MARK	DATE	DESCRIPTIONS	BY	CH'D	CCO#
REVISIONS					
⚠2	01/31/07	CORROSION PROTECTION	JD	AS	16
⚠1	01/21/06	W2 CAP BEAM ISD	JD	NV	23

CONTRACT CHANGE ORDER NO. 16
SHEET 2 OF 12

SAN FRANCISCO OAKLAND BAY BRIDGE
EAST SPAN SEISMIC SAFETY PROJECT
SELF-ANCHORED SUSPENSION BRIDGE
(SUPERSTRUCTURE & TOWER)

W2 CAP BEAM POST-TENSIONING DETAILS NO. 1

TOP TENDON LAYOUT PLAN ("E" Line)

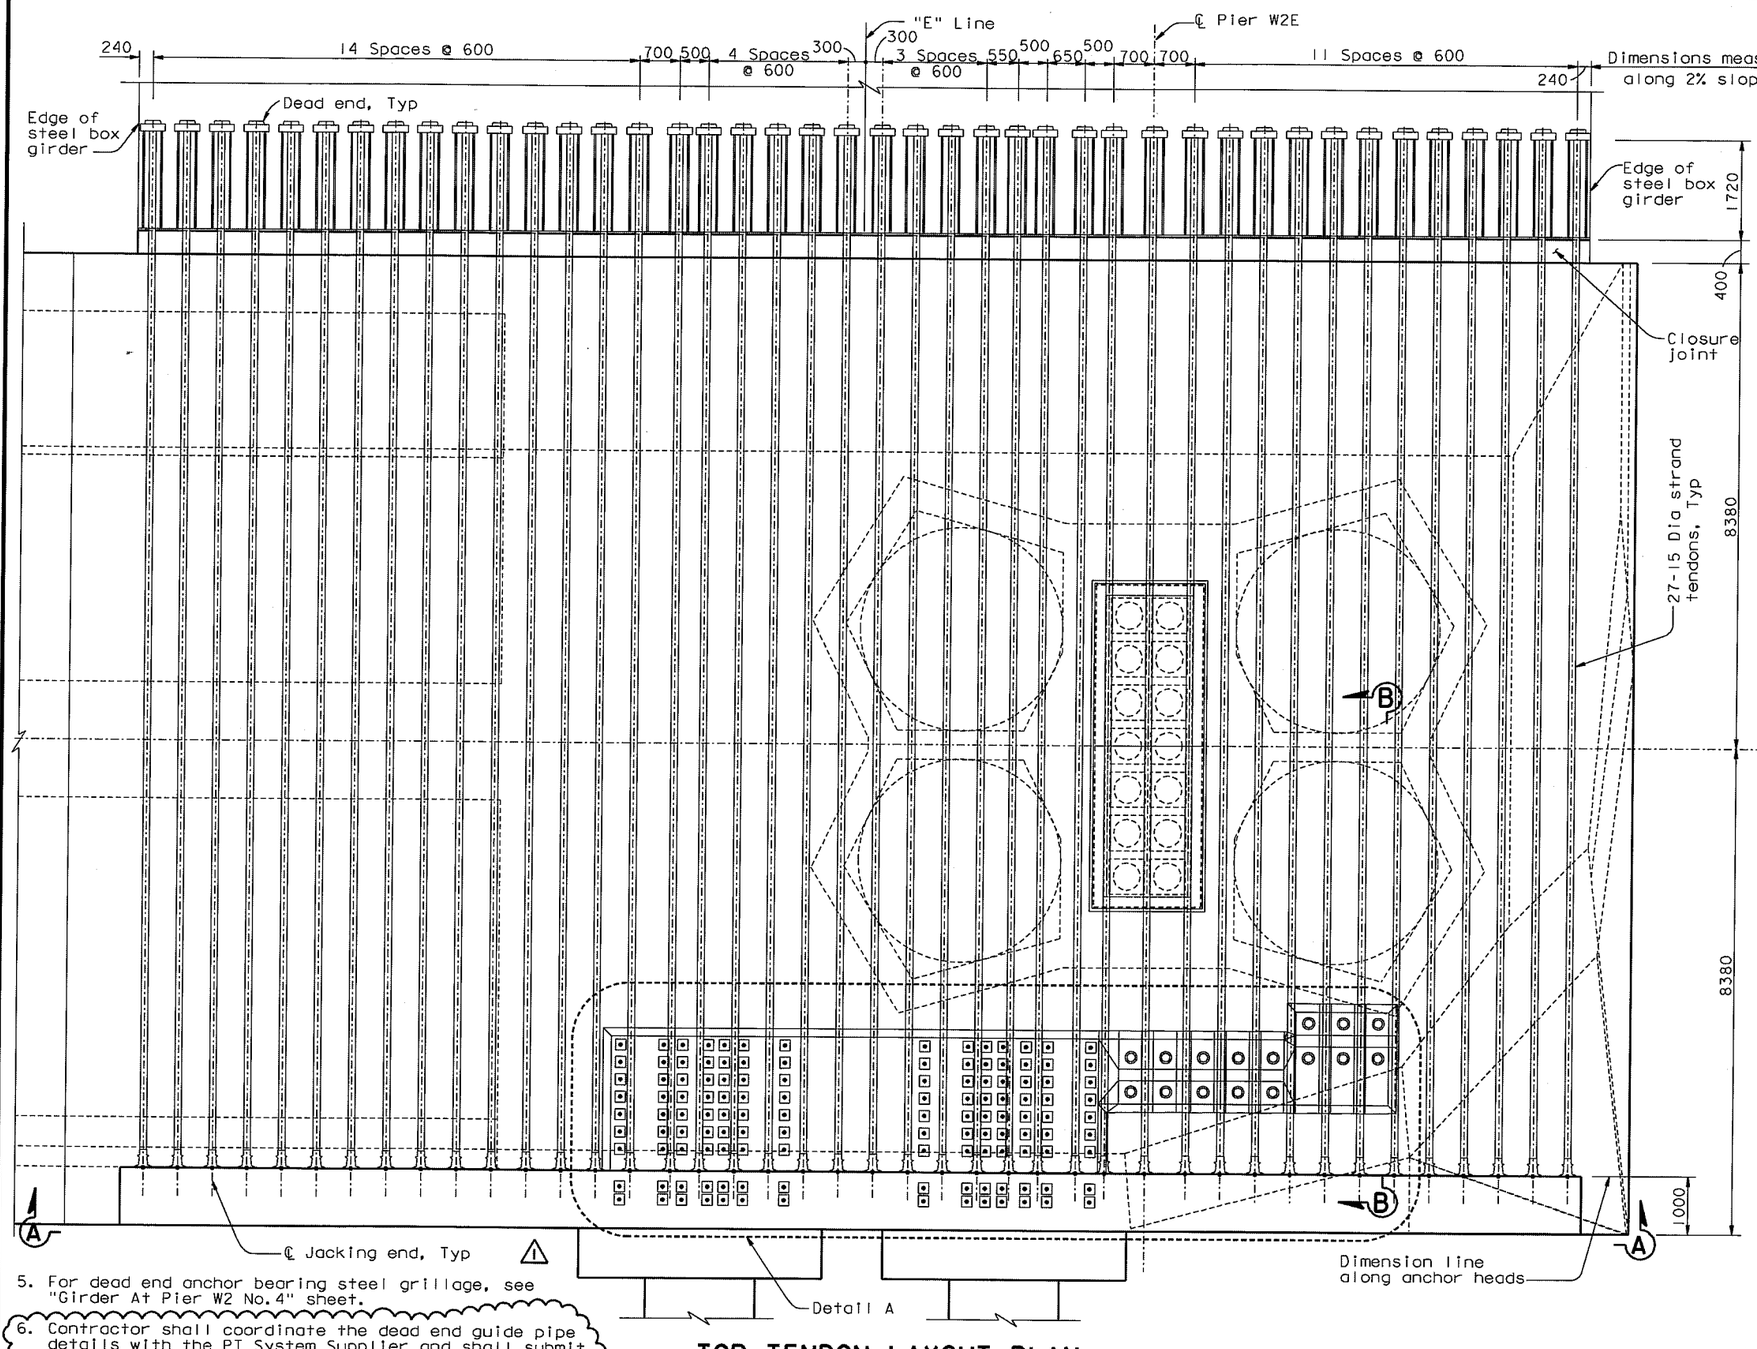
6. Contractor shall coordinate the dead end guide pipe details with the PT System Supplier and shall submit them to the Engineer for review and approval. Contractor shall grout the guide pipe after stressing operations have been completed. 2

⚠2 **ELEVATION** (Cap beam transverse PT tendons)
1:50

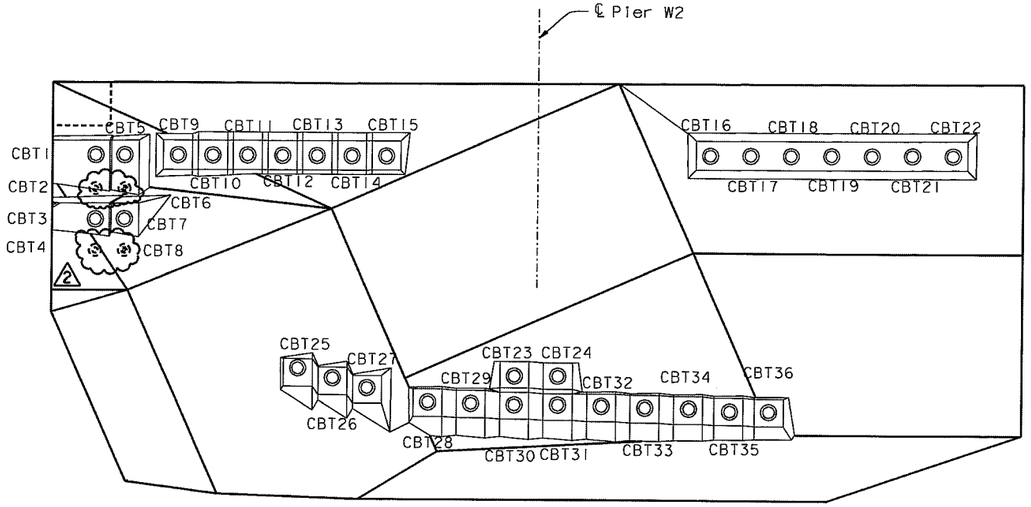
MARK	DATE	DESCRIPTIONS	BY	CH'D	CCO#
		REVISIONS			
⚠2	01/31/07	CORROSION PROTECTION	JD	AS	16
⚠1	07/21/06	W2 CAP BEAM ISD	JD	NV	23

2 DEAD END GUIDE PIPE
NTS (see Note 6)

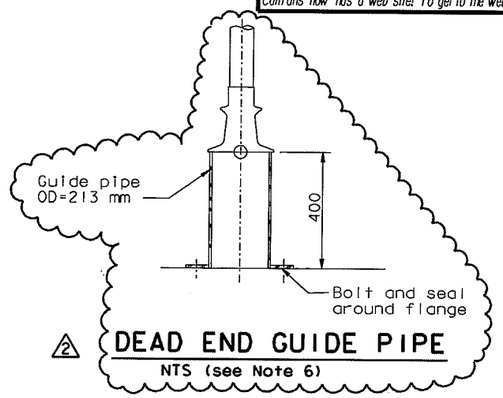
1. Cap beam reinforcement not shown for clarity.
2. Local confining spiral reinforcement for tendon anchors shall be provided by PT tendon hardware supplier.
3. Blockouts on the cap beam "E" Line shown, blockouts on the cap beam "W" Line similar.
4. 1 For Details A and C, see "W2 Cap Beam Blockout Details No. 12" sheet.
5. For additional prestressing details, see "Prestressing Notes" sheet.
6. 2 Contractor shall coordinate the dead end guide pipe details with the PT Supplier and shall submit them to the Engineer for review and approval. Contractor shall grout the guide pipe after stressing operations have been completed.
